Technical Service Bulletin

21 Mil on - P0299 Negative pressure deviation, turbocharger excessive wastegate play

21 13 13 2031245/4 April 4, 2013. Supersedes Technical Service Bulletin Group 21 number 13-12 dated April 1, 2013 for reasons listed below.

Figure 3. (1) Maximum opening of clip, (2) Position of original circlip

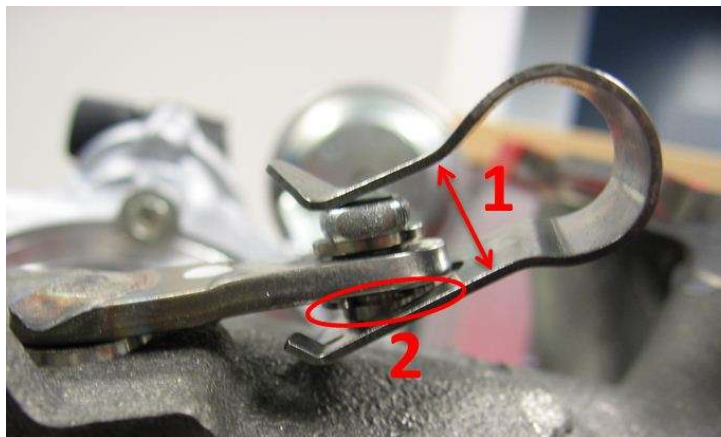
- The spring clip must not be overstretched. The maximum opening of the spring clip is 14 mm (Figure 3, 1).
- The spring clip must be replaced after every removal.

Figure 5. (1) Maximum opening of clip, (2) Position of original circlip

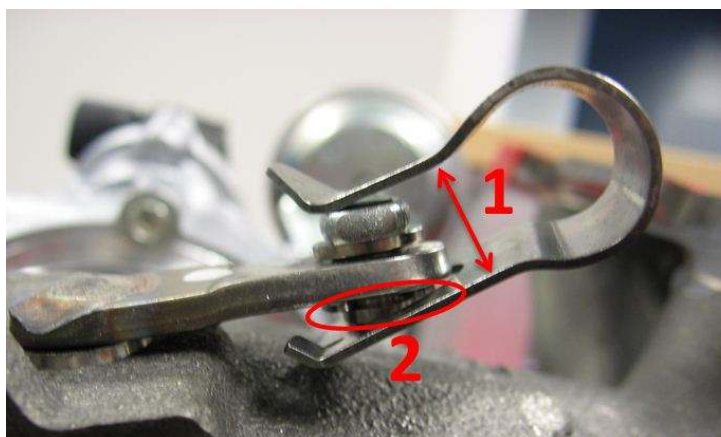
4. After fitting the spring clip, check the position of the original circlip (Figure 5, 2) and correct it if necessary.
